MARTIN LUTHER KING, JR. PLAZA

Final Environmental Impact Report and Environmental Impact Statement

State Clearinghouse Number 93061050

The Final EIR/EIS Addendum responds to comments on the Draft EIR/EIS and makes revisions to the Draft EIR/EIS as necessary in response to these comments.

FIGURE 12A

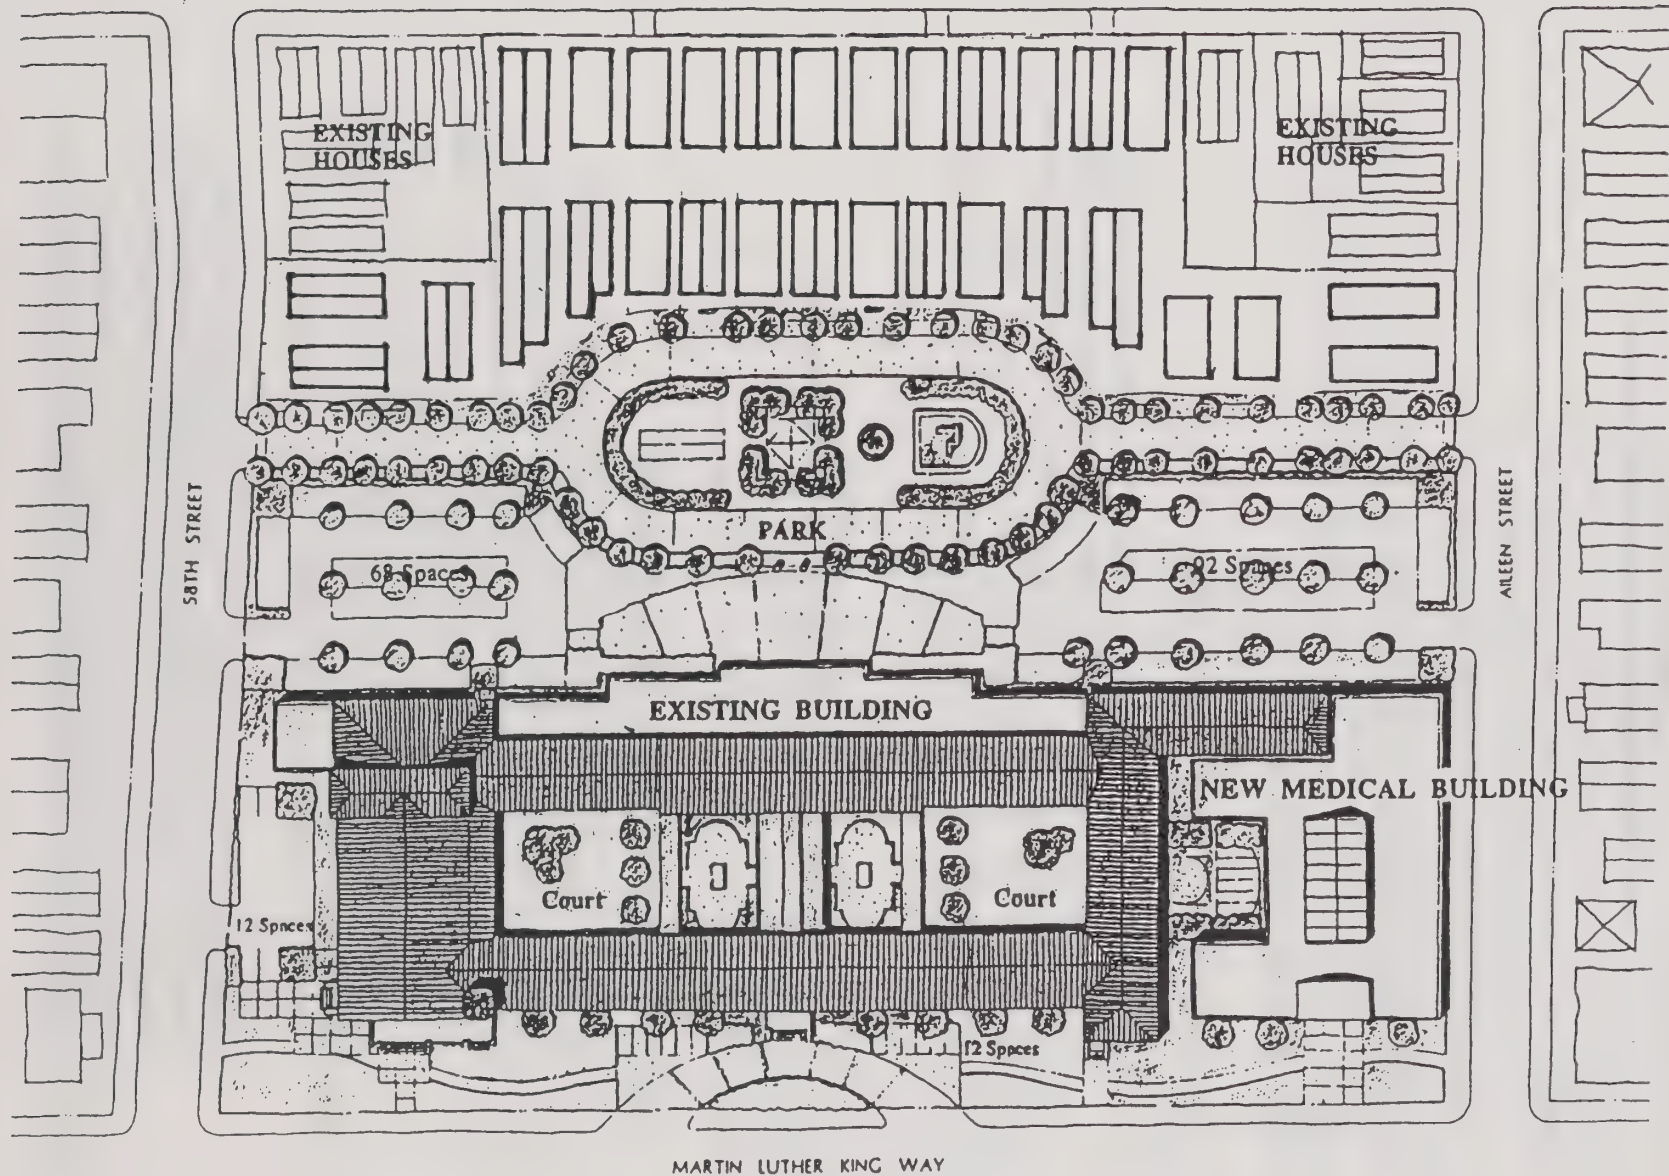
A Mitigated Alternative has been developed to incorporate many of the mitigation measures recommended for Alternatives 2 through 5. This alternative would provide medical and other uses similar to those in Alternative 3: Medical Rehabilitation, and a site plan similar to that of Alternative 2: Maximum Conventional Housing and Retail. The medical use would be where the Alternative 2 retail use would have been. The size of the medical facility in the Mitigated Alternative would be between the size of the retail facility in Alternative 2 and the medical facility in Alternative 3, and the number of housing units would be between the numbers of units in Alternatives 2 and 3. Community service facilities would be about the same size as in Alternative 3, and fitness and retail facilities would be smaller than in Alternative 3. Figure 12A shows a conceptual site plan for the Mitigated Alternative.

The Mitigated Alternative has not been reviewed at the level of detail accorded the other alternatives in this EIR/EIS, since it is an amalgamation of the other alternatives and has been formulated specifically to address the impacts of the other alternatives. No further analysis of the Mitigated Alternative is required under CEQA or NEPA, since it is within the range of the other alternatives. Table 44A, in Chapter V, shows the significant impacts that would occur and the mitigation measures that would be required if the Mitigated Alternative were implemented.

FIGURE 35

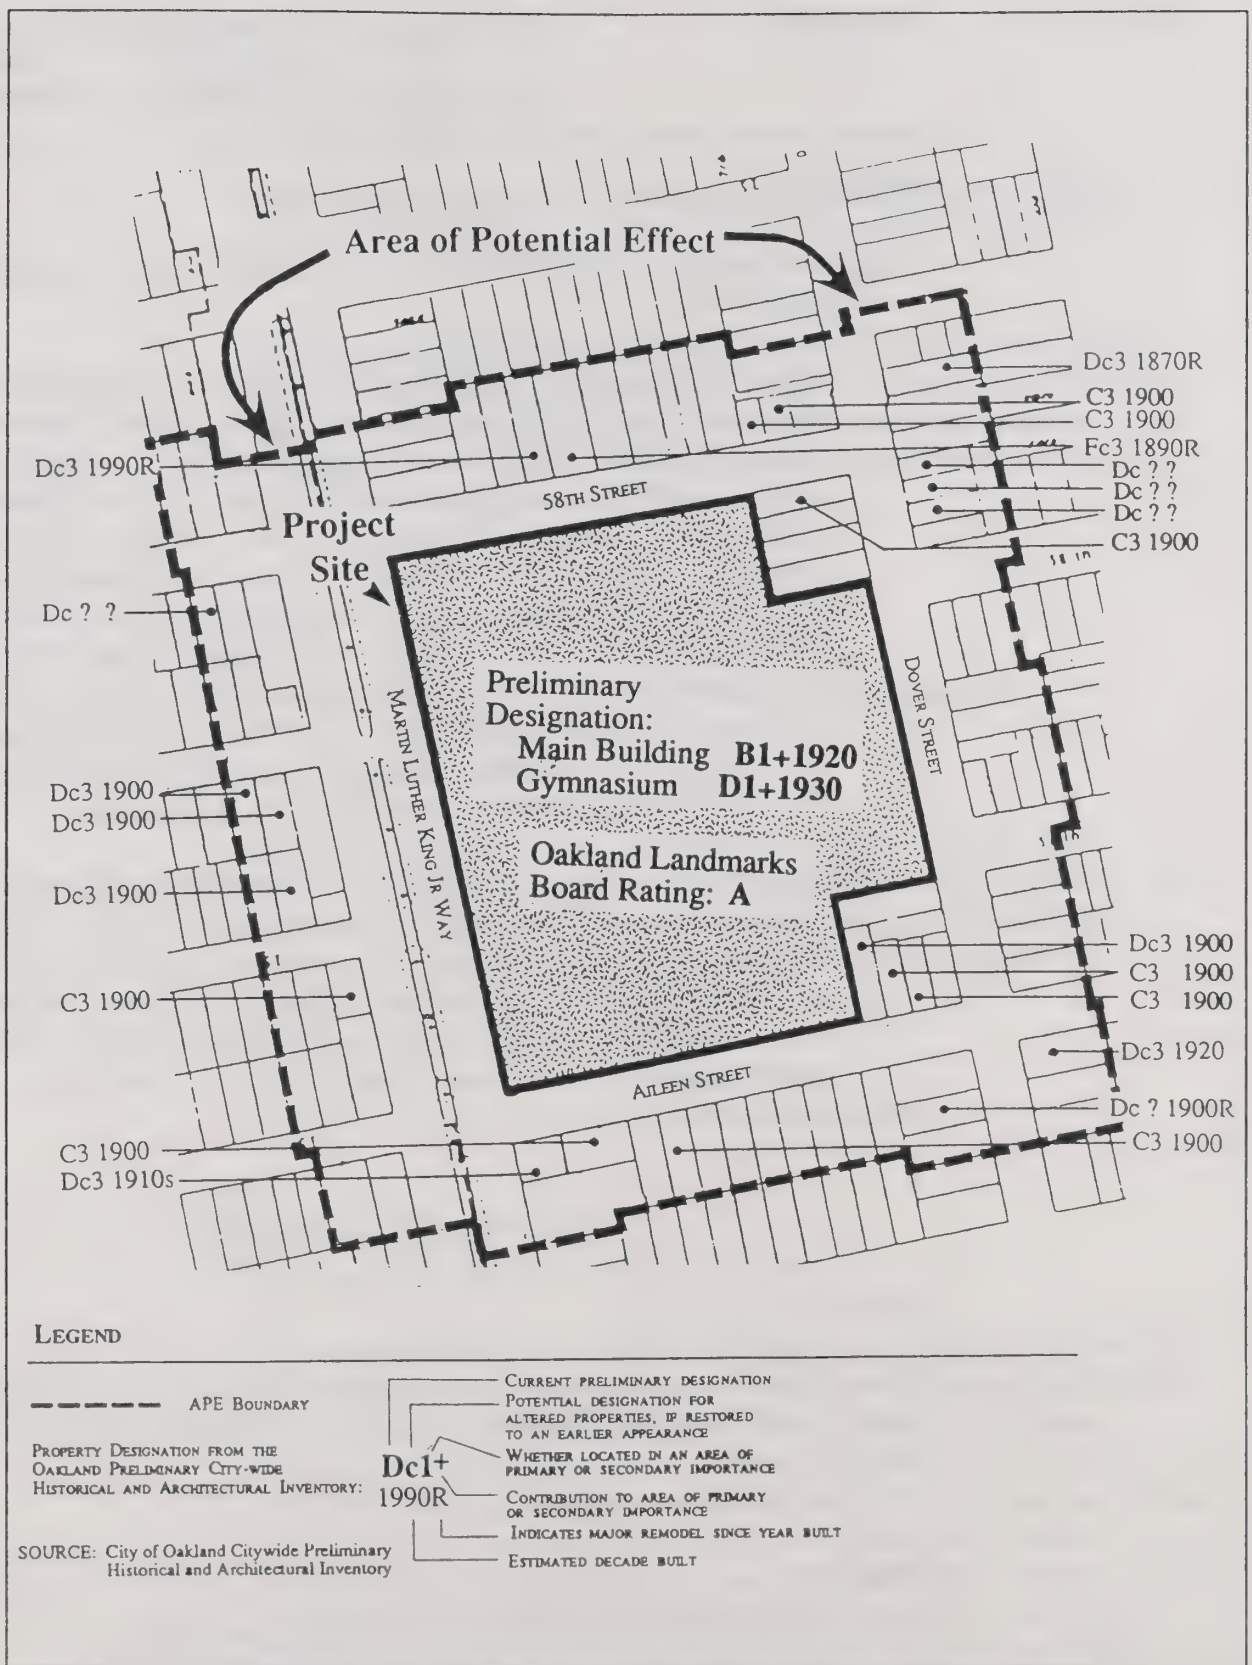
Figure 35 has been updated to include the 1990 Oakland Landmarks Board rating as well as the 1986 Oakland Cultural Heritage Survey preliminary designation.

8-4 4. Cultural Resources (Pages 269, 291-4) It is not clear whether the Area of Potential Effect, as illustrated in Figure 35, has been agreed to by the State Office of Historic Preservation as adequately describing the area where the proposed project could affect historic resources. Given the possible traffic impacts described elsewhere in the report, it would appear that the APE should be expanded to determine whether there are historic resources which would be affected by traffic and noise, particularly along Aileen Street between the project and Telegraph.

Response 9-7. Figure 35 on page 270 of the Draft EIR/EIS has been updated to reflect the final rating given to the buildings in 1990 by the

In 1986, the Oakland Cultural Heritage Survey had given the main building a preliminary designation of B1+ and the gymnasium a preliminary designation of D1+. As part of the landmark application
